VOGTLE ELECTRIC GENERATING PLANT
REQUEST TO REVISE TECHNICAL SPECIFICATIONS
REVISION TO REACTOR PRESSURE LIMITS

MARKED UP TECHNICAL SPECIFICATION PAGES

VOGTLE ELECTRIC GENERATING PLANT REQUEST TO REVISE TECHNICAL SPECIFICATIONS REVISION TO REACTOR PRESSURE VESSEL LIMITS

EXEMPTION REQUEST

Figure 3.4-3b

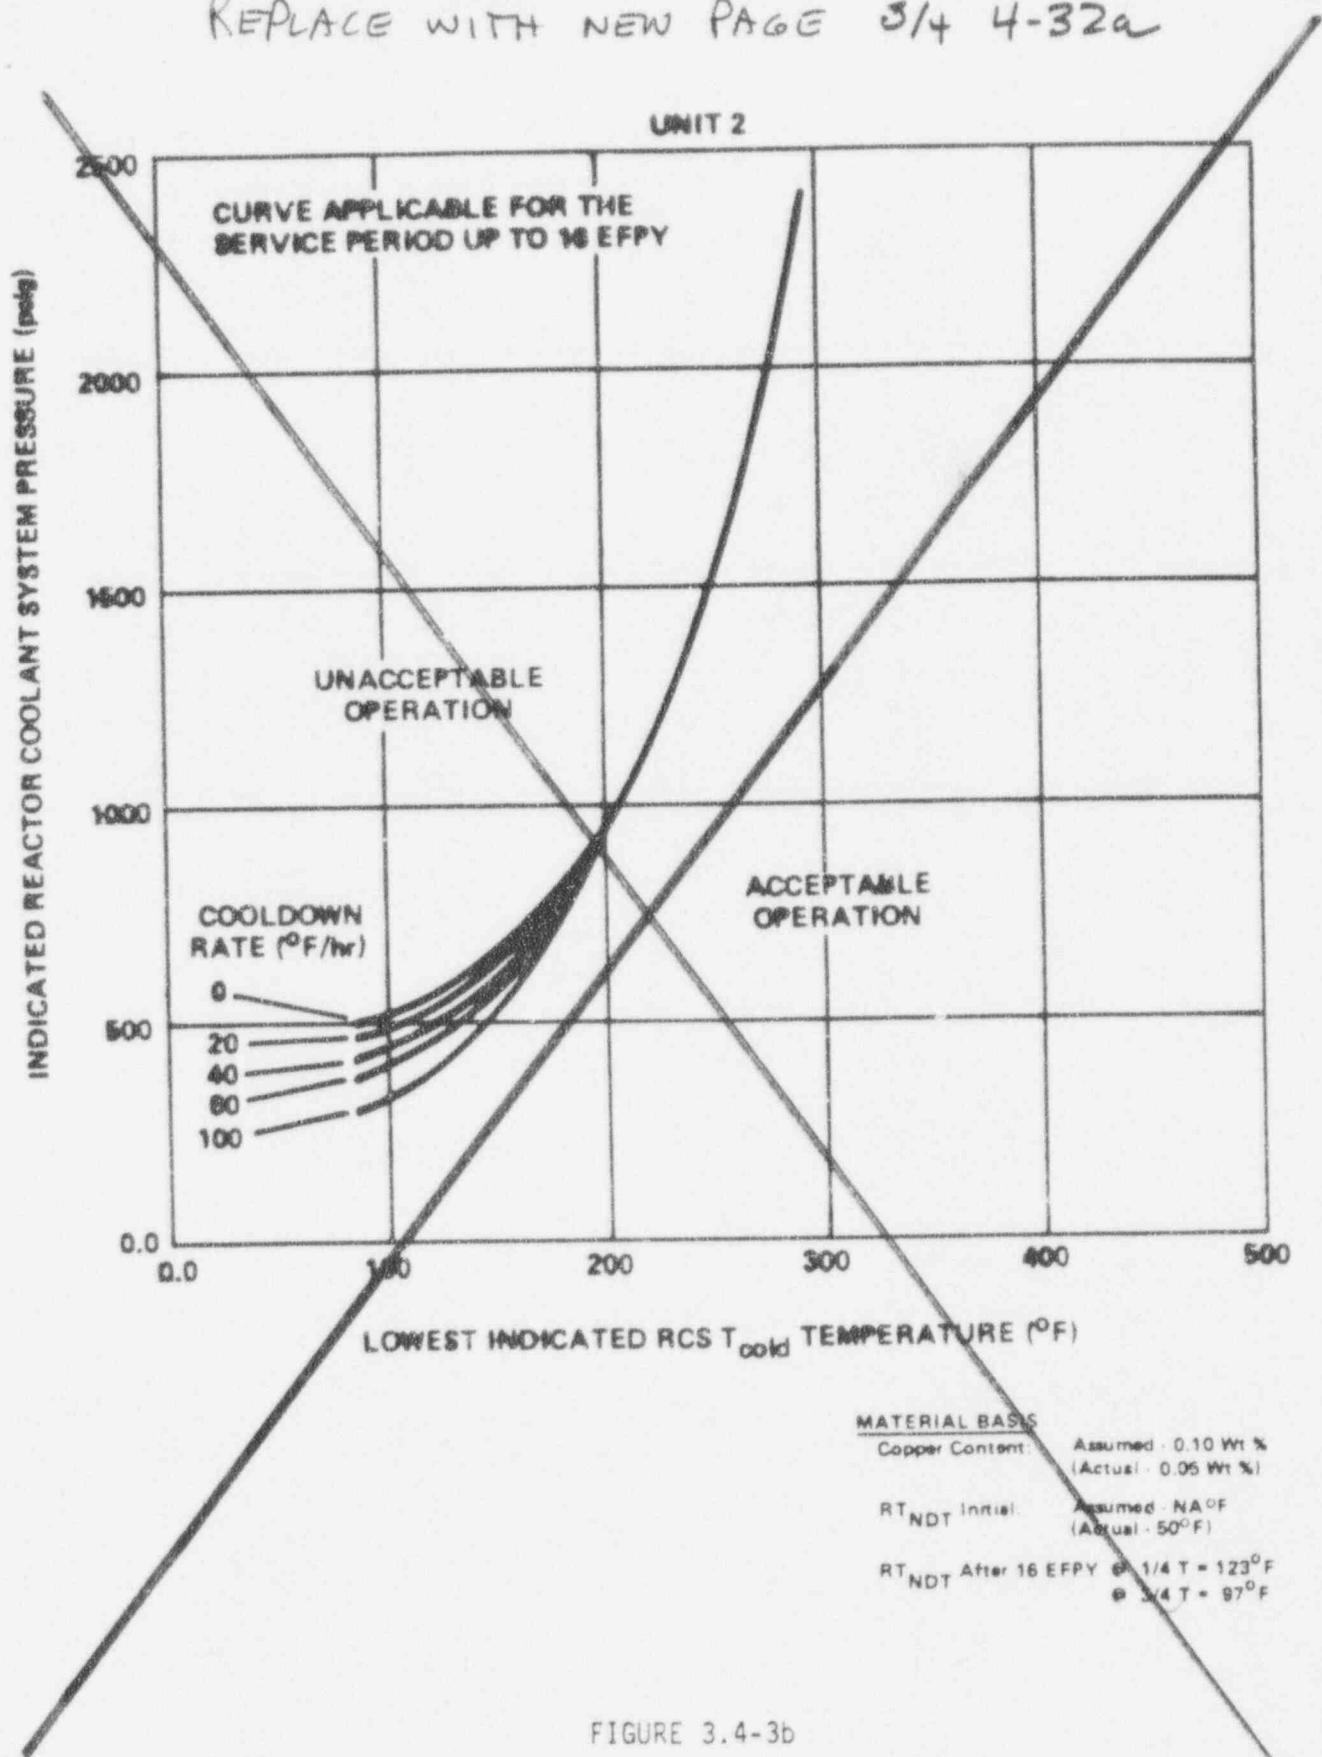
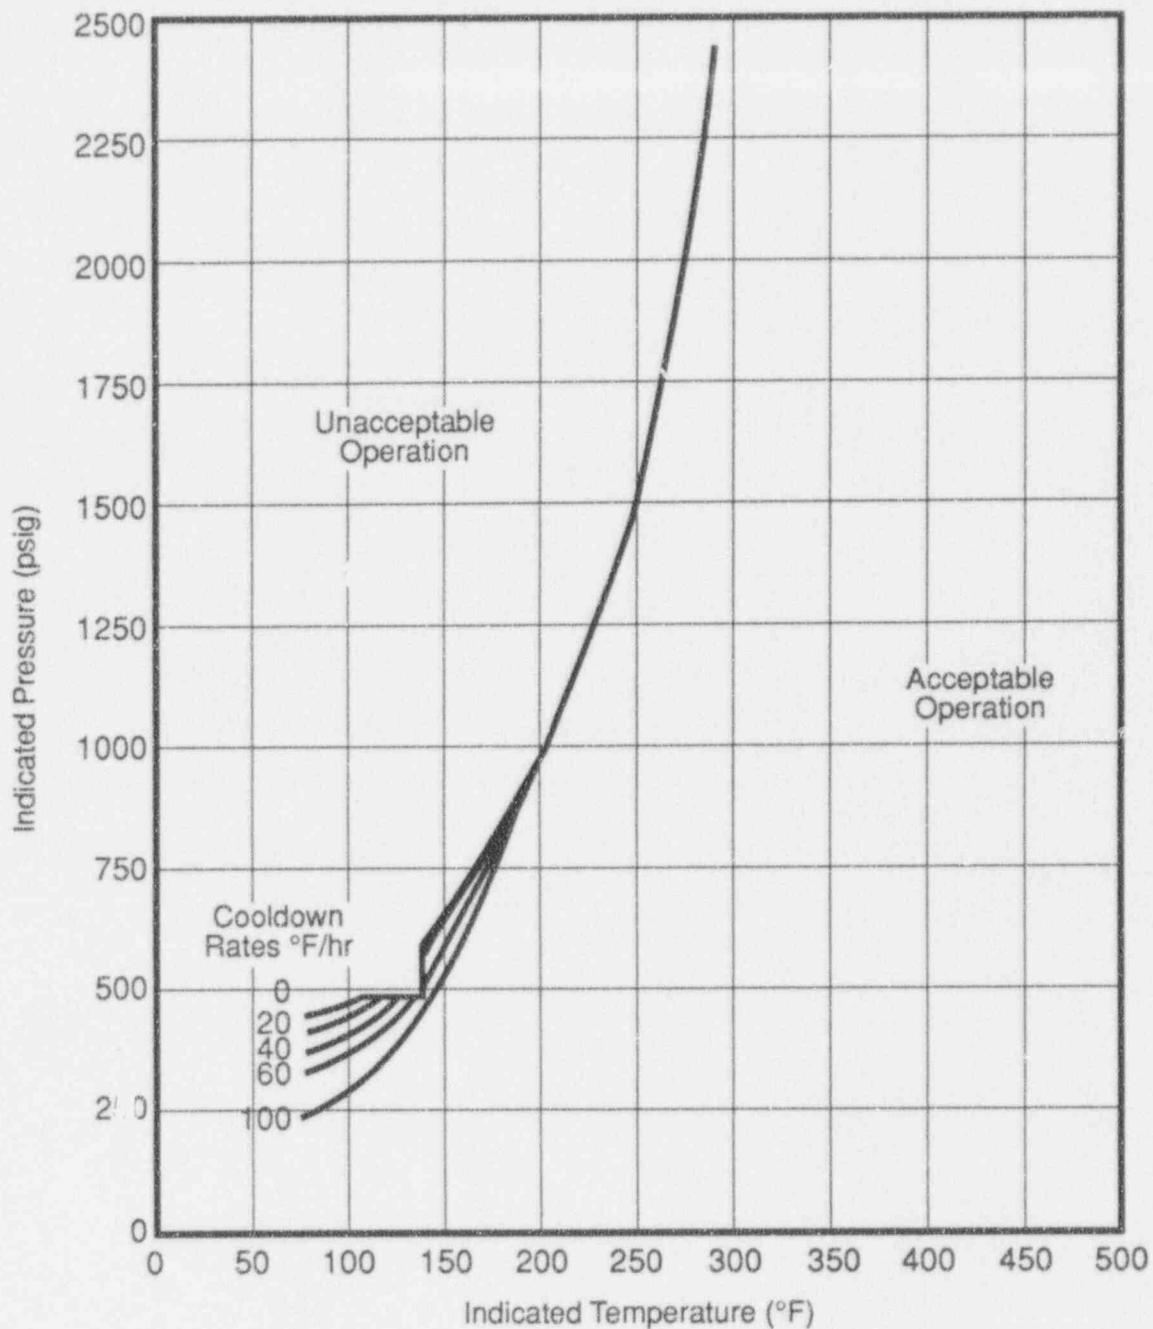
REPLACE WITH NEW PAGE 3/4 4-32a

Copper Content:	Assumed - NA WT% (Actual - 0.05 WT%)
RT _{NDT} Initial:	Assumed - NA °F (Actual - 50°F)
RT _{NDT} At 16 EFPY:	@ 1/4T = 112°F @ 3/4T = 94°F

Unit 2 Reactor Coolant System Cooldown Limitations (Cooldown rates up to 100°F/hr)
Applicable for the First 16 EFPY (With Margins of 10°F and 60 psig for Instrumentation
Errors and Margin of 74 psig for Pressure Difference Between Pressure Instrumentation
and Reactor Vessel Beltline Region).

Figure 3.4-4a
Unit 1 Maximum Allowable Nominal PORV Setpoint for
the Cold Overpressure Protection System

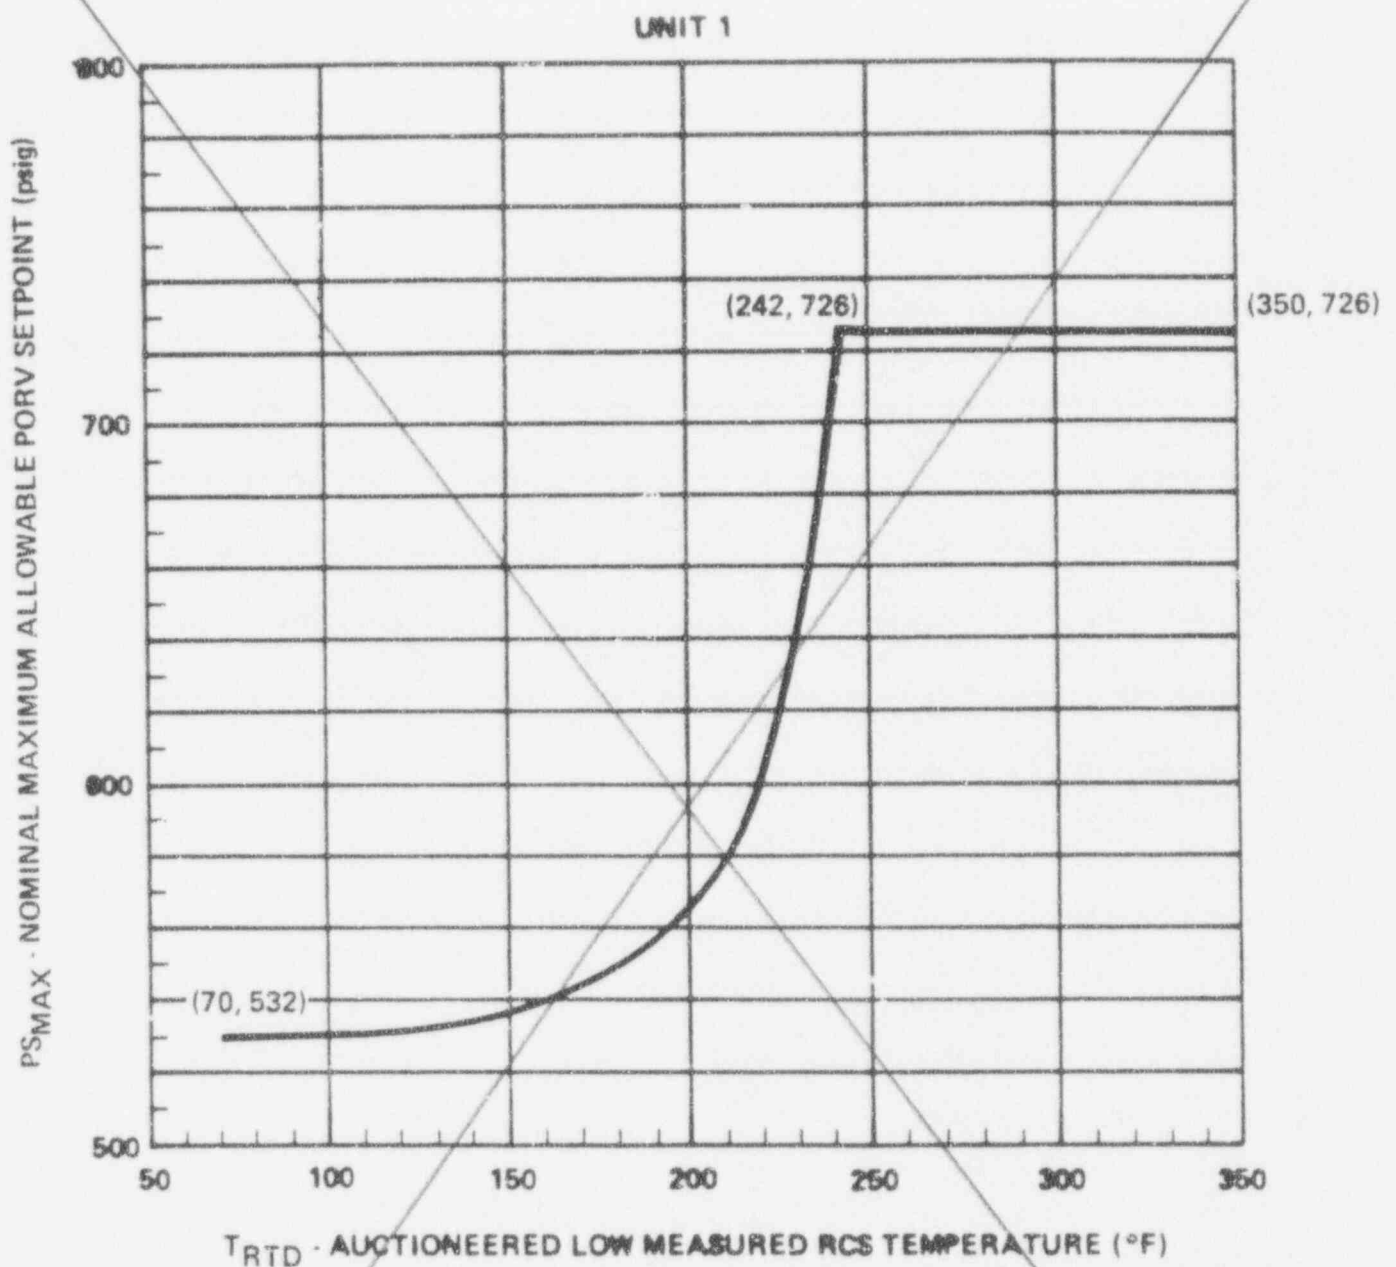
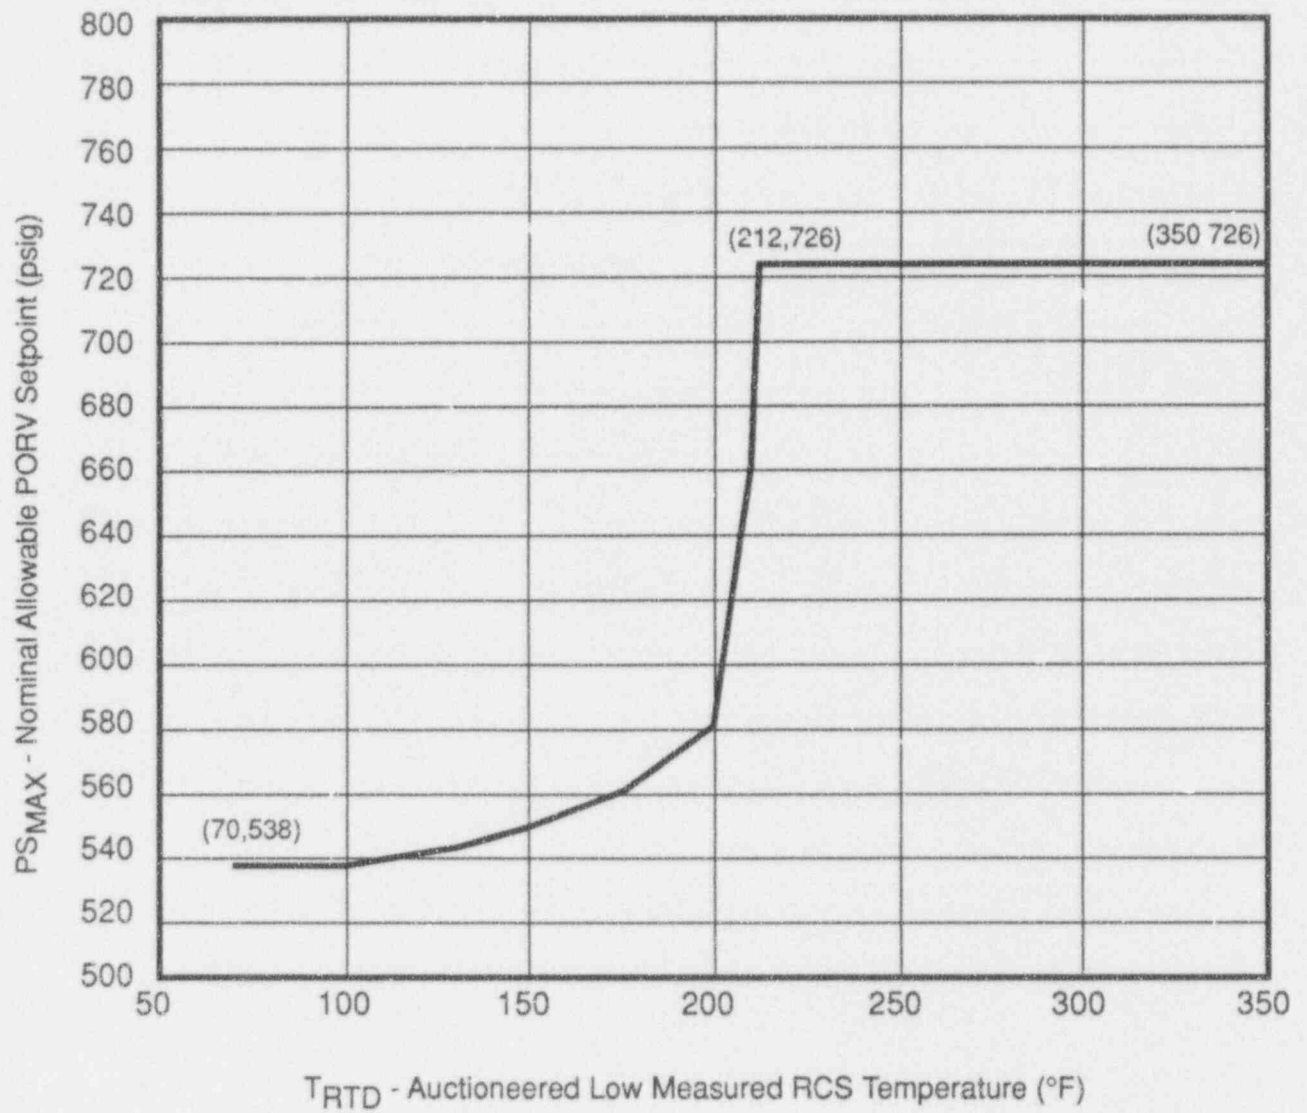
REPLACE WITH NEW PAGE 3/4 4-35

Figure 3.4-4b
Unit 2 Maximum Allowable Nominal PORV Setpoint for
the Cold Overpressure Protection System

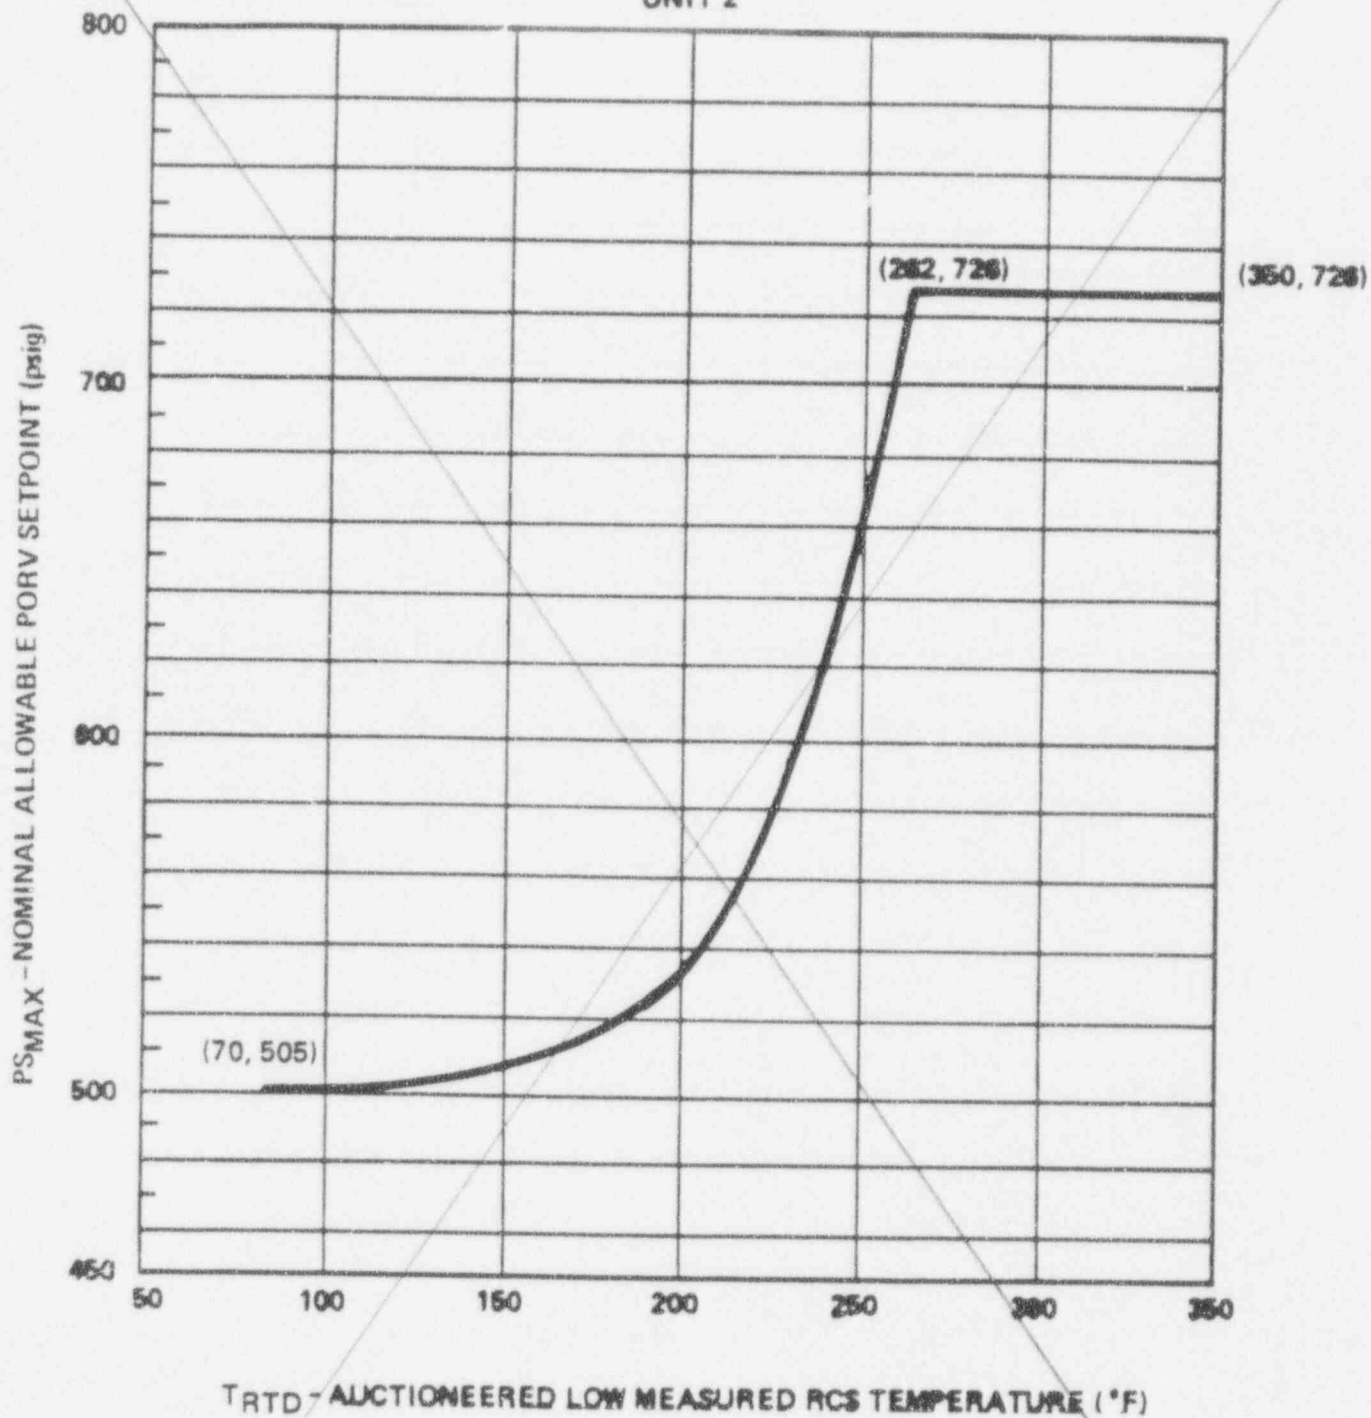
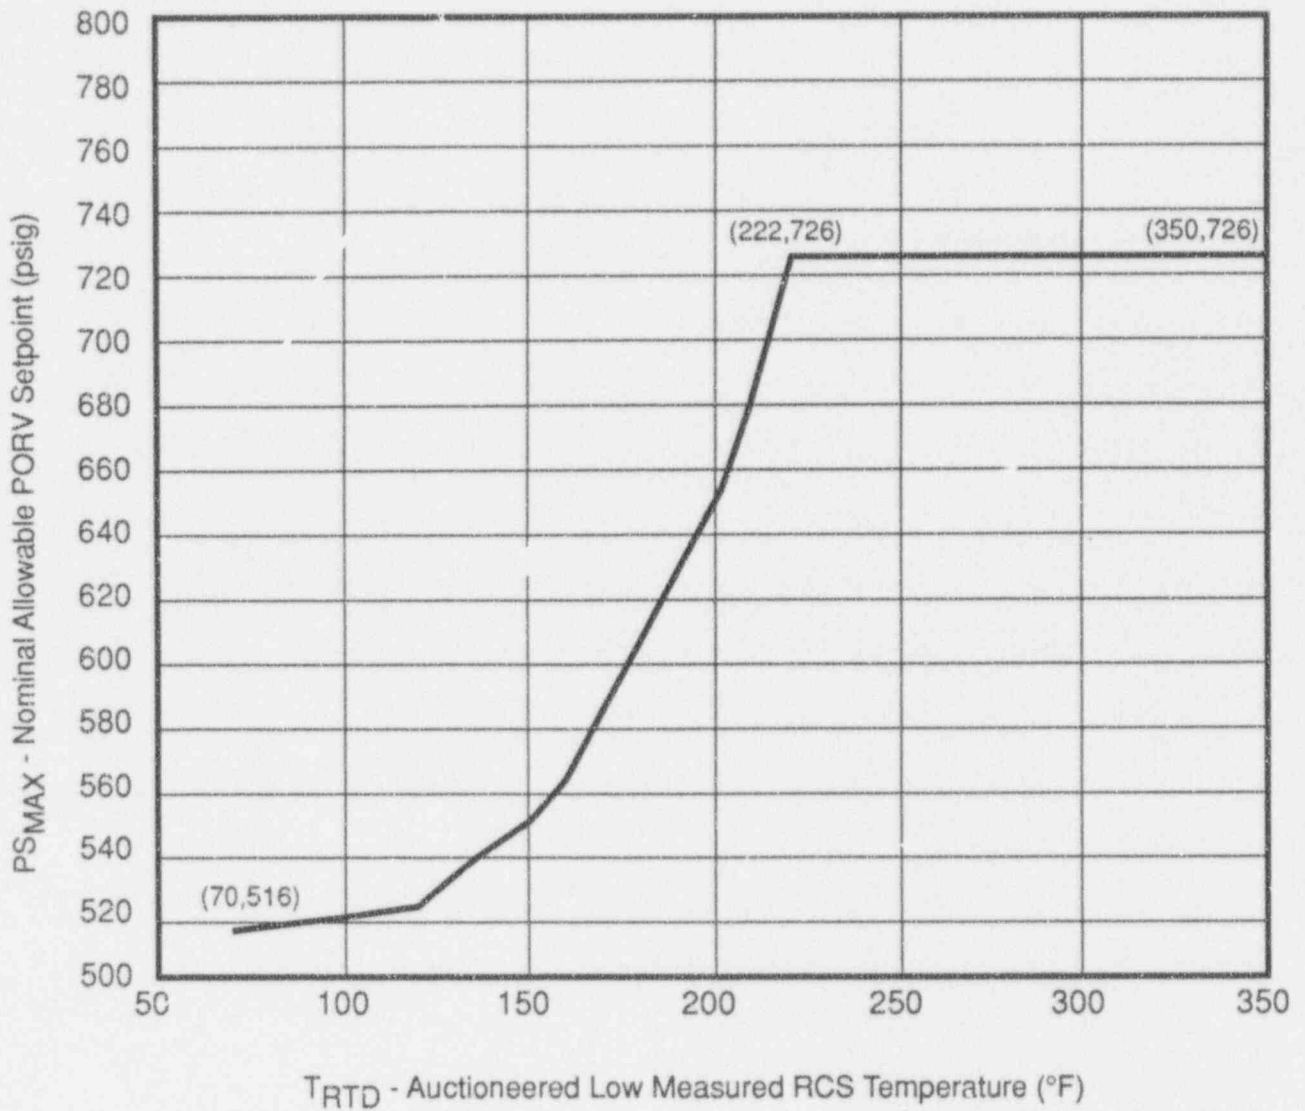
REPLACE WITH NEW PAGE 3/4 4-35a
